GW - 57

**GENERAL  
CORRESPONDENCE**

Re: TEPPCO NGL Pipelines, LLC  
TEPPCO Val Verde System Discharge Permit Renewals  
San Juan and Rio Arriba County, New Mexico

Re: TEPPCO NGL Pipelines, LLC  
TEPPCO Pump Canyon Compressor Station  
San Juan County, New Mexico  
Groundwater Discharge Plan (GW-050) <sup>7</sup>Renewal Application

**FIGURE 1, VENT STACK COLLECTION SYSTEM**

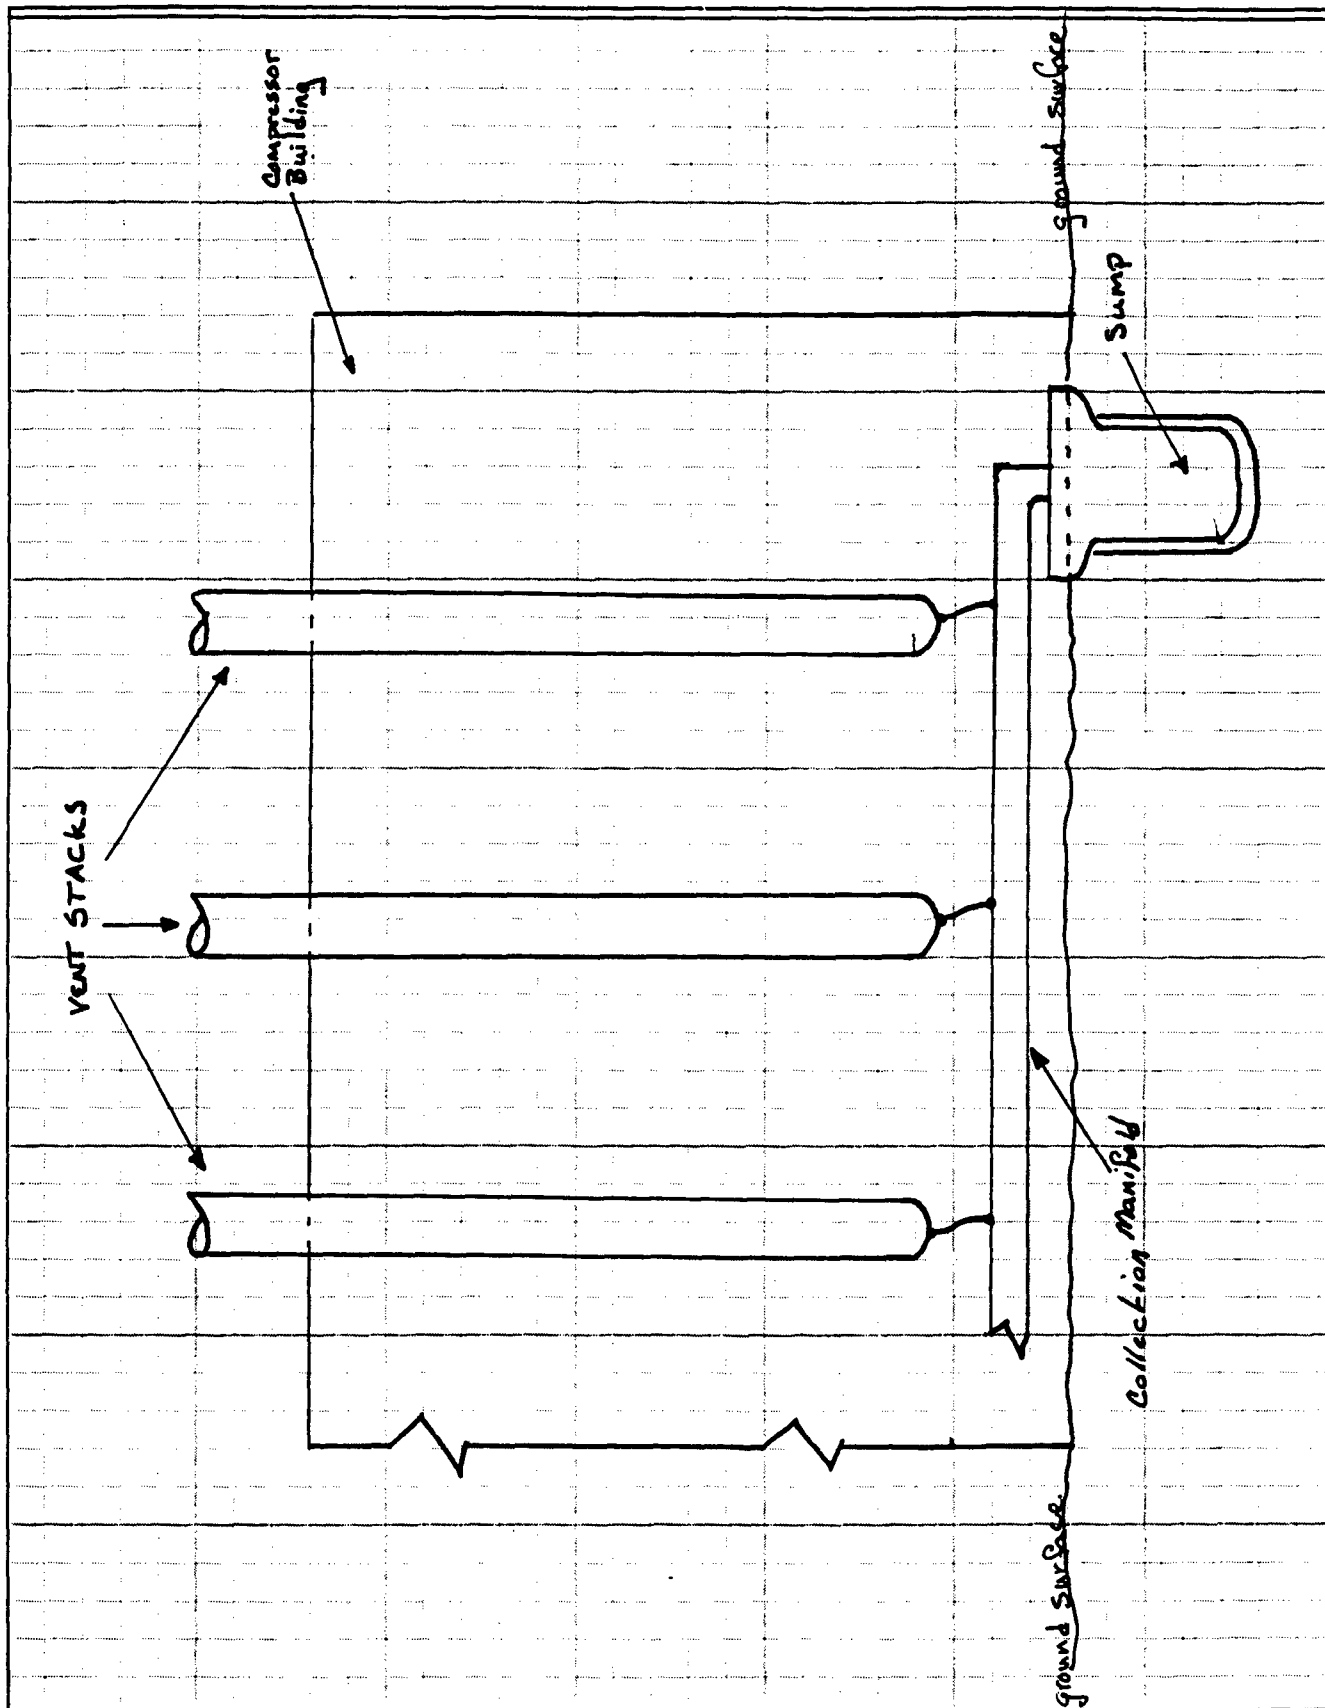
1. Plant main vent system has oil accumulating on stack and system is located in stormwater drain area. (see picture #2)

To eliminate the source of contamination, a simple manifold system was installed and attached to each weep hole at the bottom of the starting vents. The manifold system collects any fluids in the vent stacks and directs them to the onsite underground sump; rather than allowing the fluids to fall onto the ground surface. Figure 1, attached, illustrates the solution implemented at both facilities.
